Response to the Aspen – Onshore Environment Impact Assessment Scoping Report

Newtonhill, Muchalls & Cammachmore Community Council

[23rd July 2026]

Figure 1 SEPA Flood map

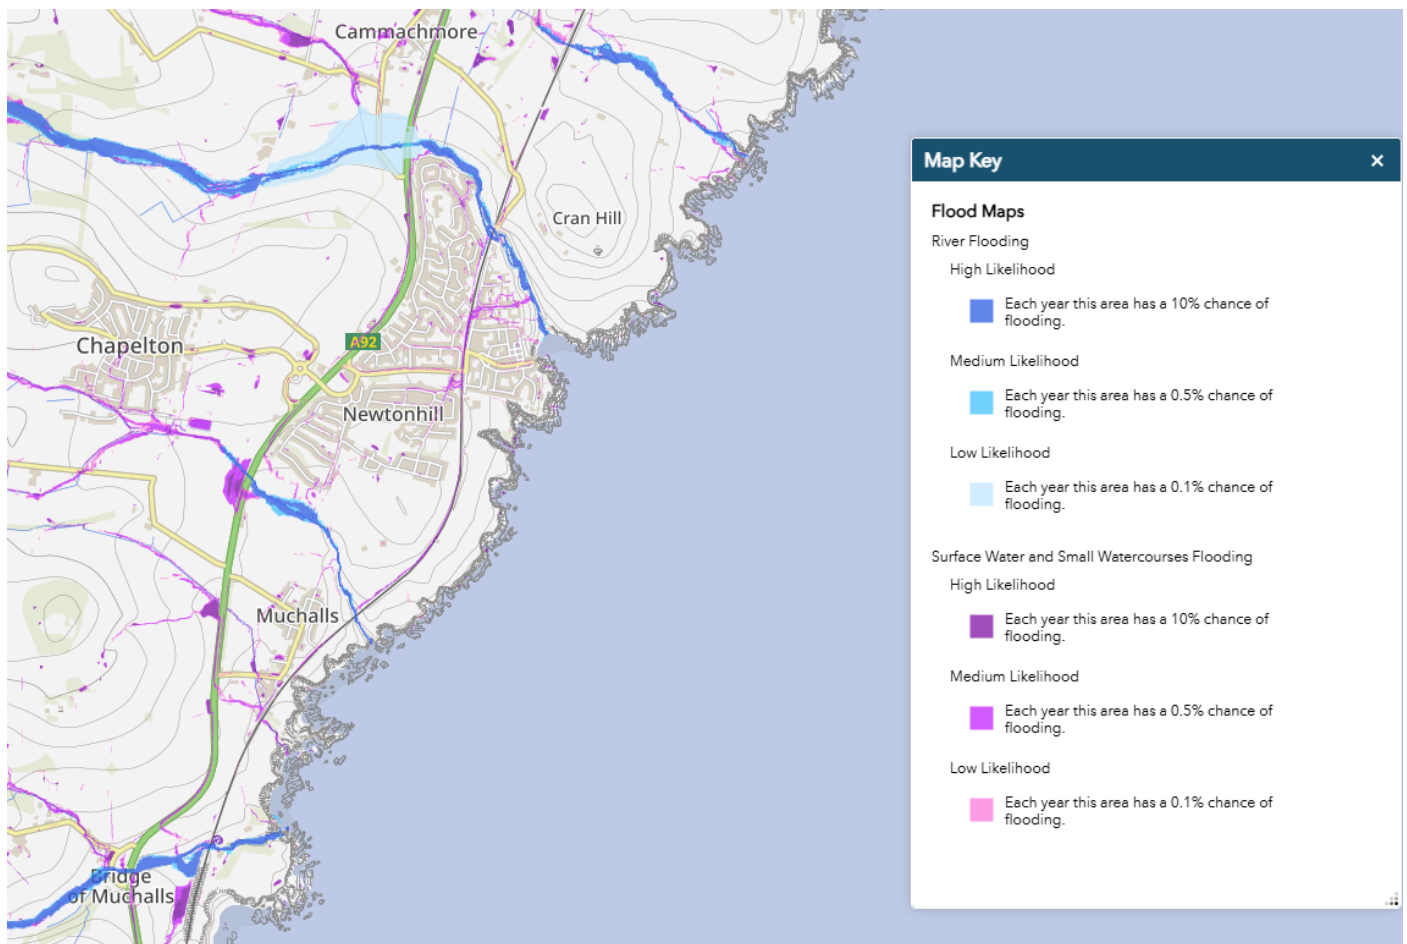
Scoping Report section 13.5.1 describes the flood risk for the Elsick Burn as Moderate, however the SEPA flood map (Figure 1) shows the flood risk to be High. The Elsick Mill has suffered extensive flooding and has installed flood defences. In 2016, Network Rail undertook scour protection work to Elsick railway viaduct piers.

Scoping Report section 13.5.9 cites the British Geological Society (BGS) 1:625 hydrogeological map. Whilst the map shows a low productive aquifer in most areas, there is a moderately productive aquifer on the hill immediately to the north of the Elsick Burn between the A92 and the East Coast Railway. Cable trench excavation in this area could lead to additional flooding. Extra measures need to be put in place to prevent sediment runoff contaminating the Elsick Burn and flooding the Elsick Mill again.
